Re: ***Winsome Filing No. 3 PCM Certification Letter
El Paso County, Colorado***

This letter serves as the certification for Winsome Filing No. 3, El Paso County, CO consistent with El Paso County Engineering Manual ("ECM") Section 5.10.6.B, which states that Engineering Record Drawings shall be accompanied by a certification letter from the Engineer of Record which shall state that facilities constructed provide the required storage volume, meet the required release rates, the stage areas, elevations and outlet dimensions. Winsome Filing No. 3 consists of the following drainage facilities which are included in this certification:

4 ORIFICE PLATE AND TRASH RACK DETAIL

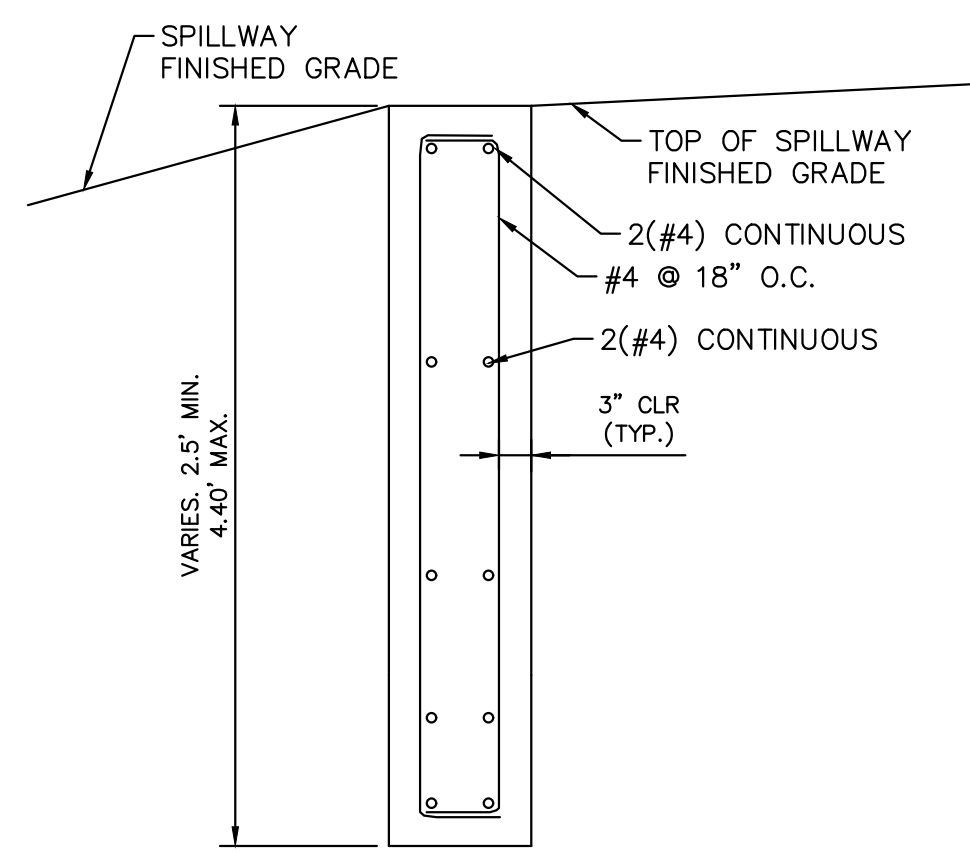
GAPS IN TRASH RACK WERE INSTALLED HORIZONTALLY, RATHER THAN VERTICALLY AS SHOWN IN THE PLAN OVERFLOW SAFETY GRATES.

11 **ROCK CHUTE #4 PROFILE- CROSS SECTION 2**
N.T.S.

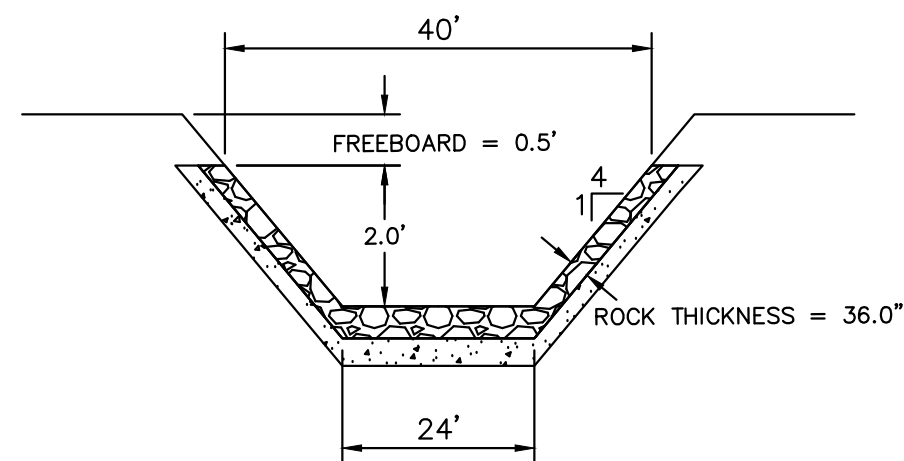
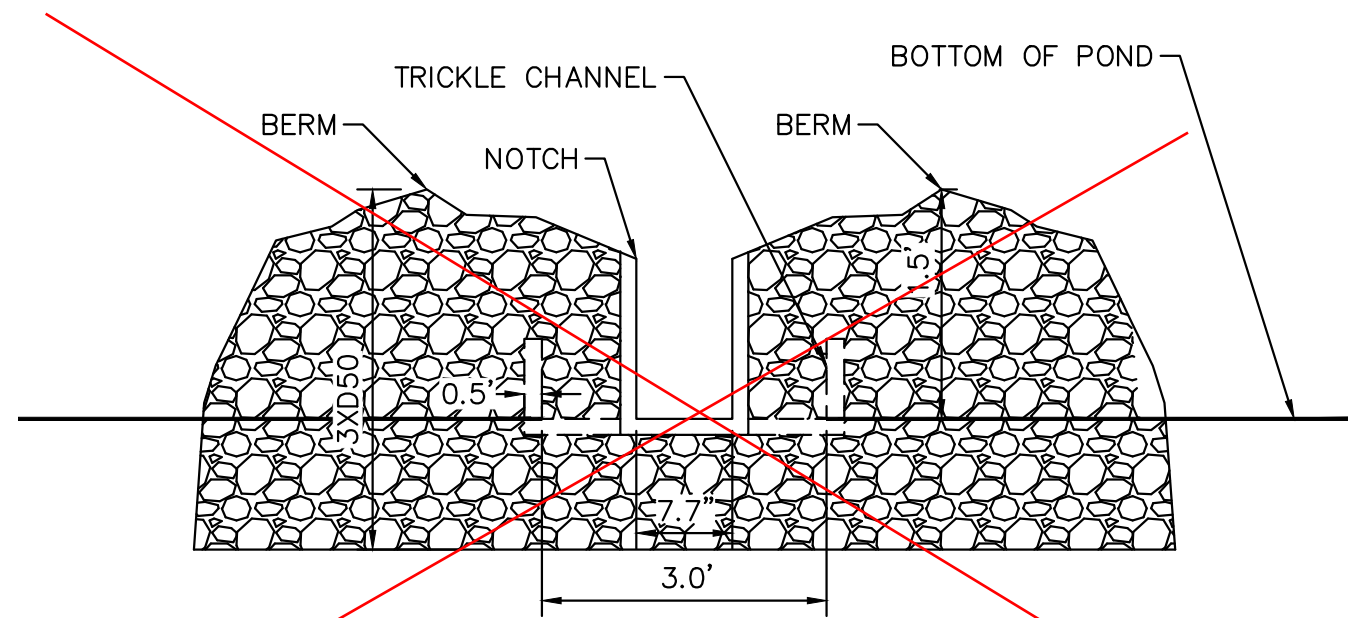
NOTCH REPLACED
WITH PVC PIPE PER
FIELD CHANGE.
VERIFIED WITH EPC
STORMWATER PIOR
TO FIELD CHANGE.
SEE PREVIOUS
SHEET

4 ORIFICE PLATE AND TRASH RACK DETAIL

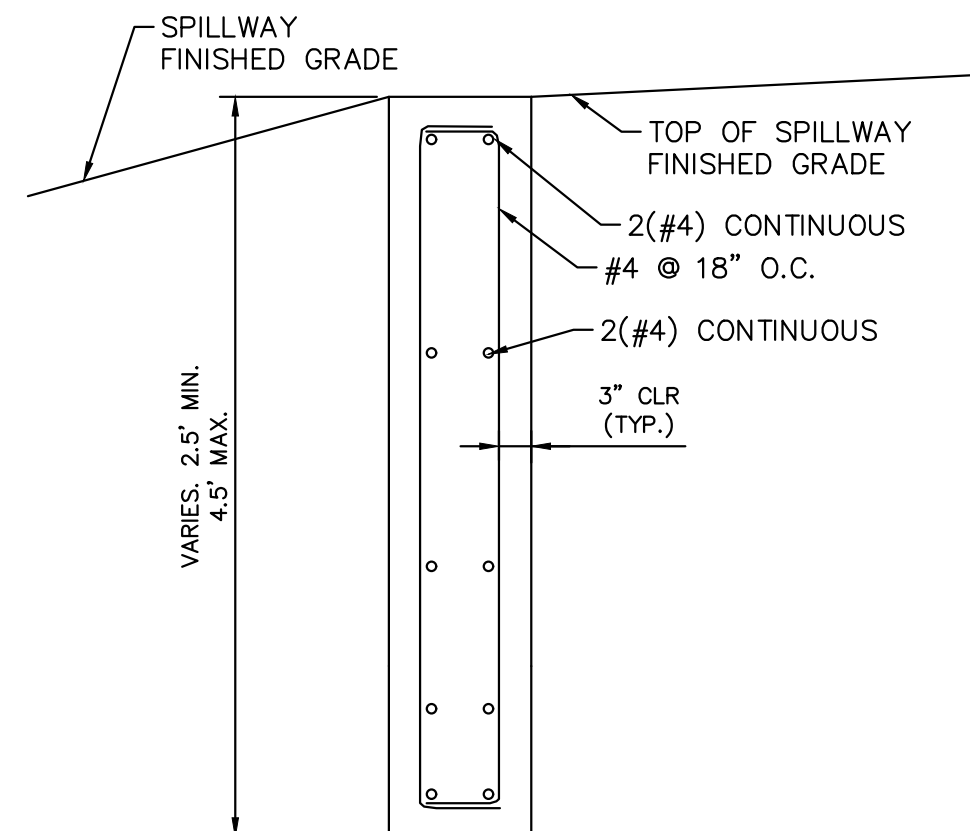
GAPS IN TRASH RACK WERE INSTALLED HORIZONTALLY, RATHER THAN VERTICALLY AS SHOWN IN THE PLAN

12 **ROCK CHUTE #6 NOTCH PROFILE**
N.T.S.

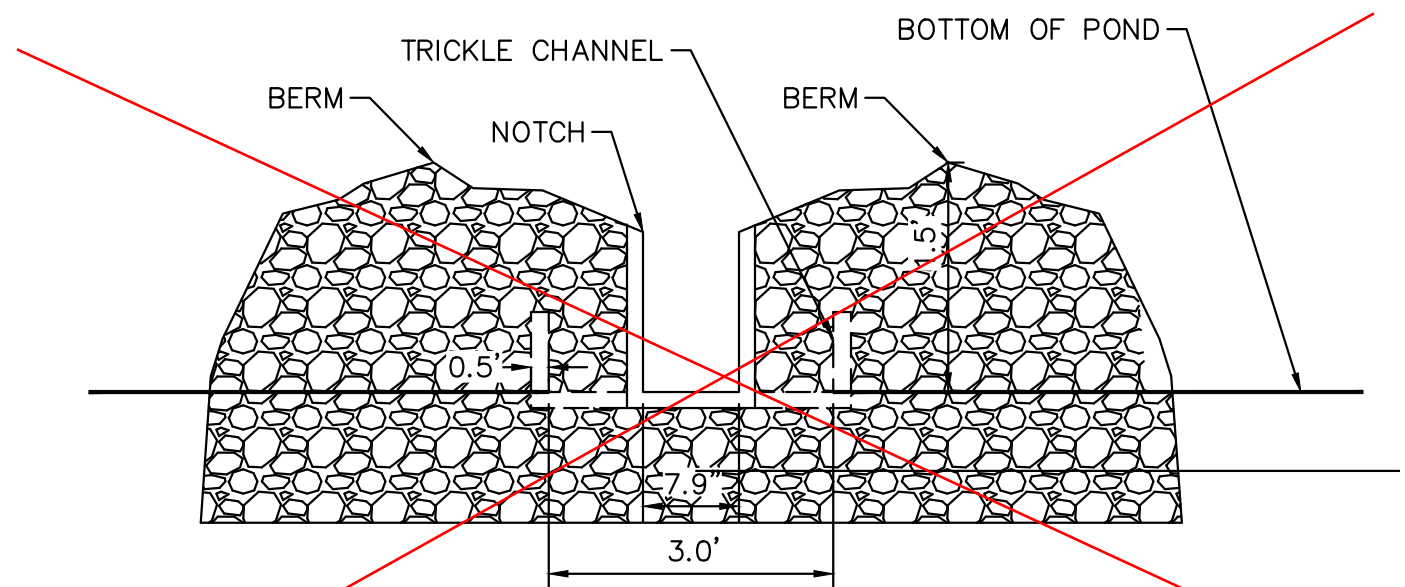
NOTCH REPLACED
WITH PVC PIPE PER
FIELD CHANGE.
VERIFIED WITH EPC
STORMWATER PIROW
TO FIELD CHANGE.
SEE PREVIOUS PAGE

4 ORIFICE PLATE AND TRASH RACK DETAIL

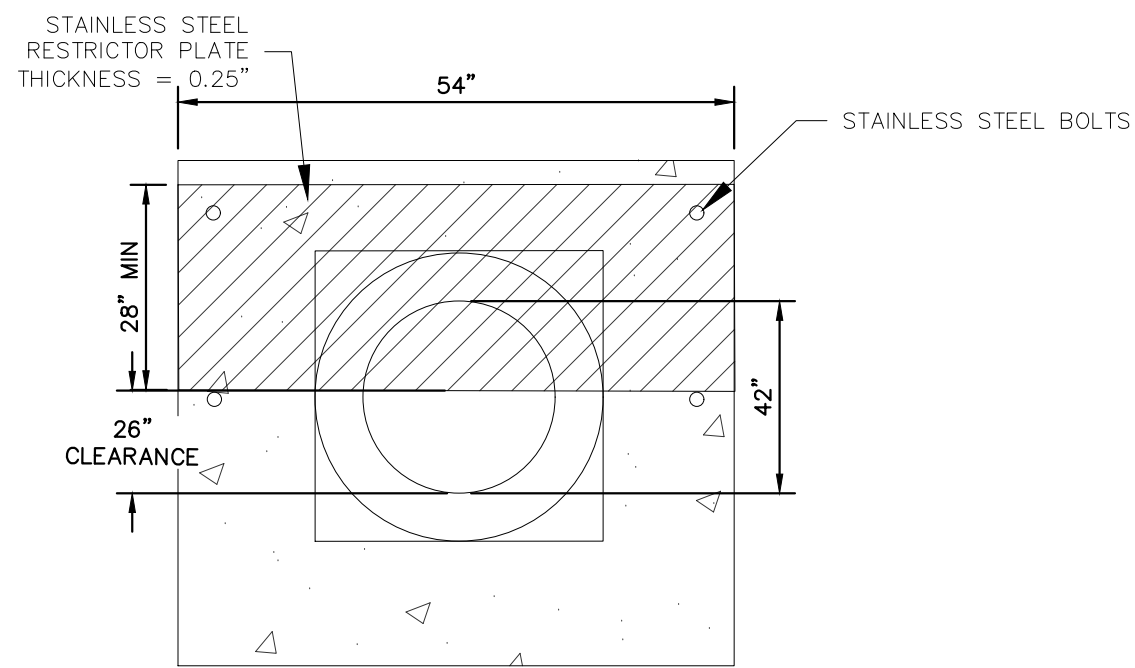
GAPS IN TRASH RACK WERE INSTALLED HORIZONTALLY, RATHER THAN VERTICALLY AS SHOWN IN THE PLAN OVERFLOW SAFETY GRATES.

13 **ROCK CHUTE #13 PROFILE- CROSS SECTION 2**
N.T.S.

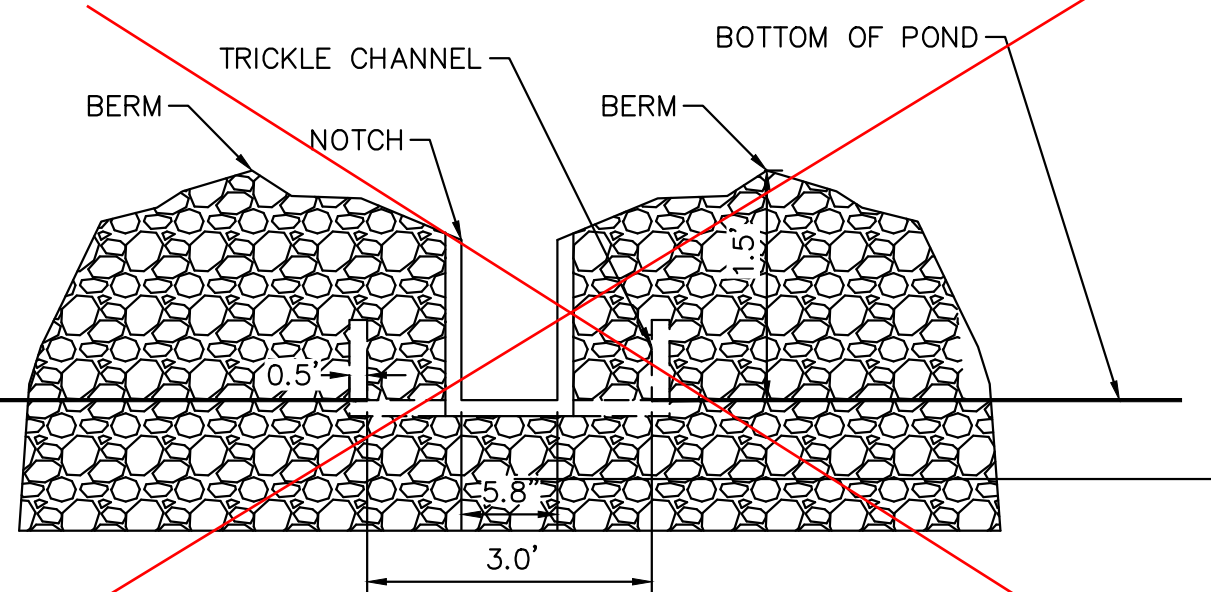
NOTCH REPLACED
WITH PVC PIPE PER
FIELD CHANGE.
VERIFIED WITH EPC
STORMWATER PIOR
TO FIELD CHANGE.
SEE PREVIOUS PAGE
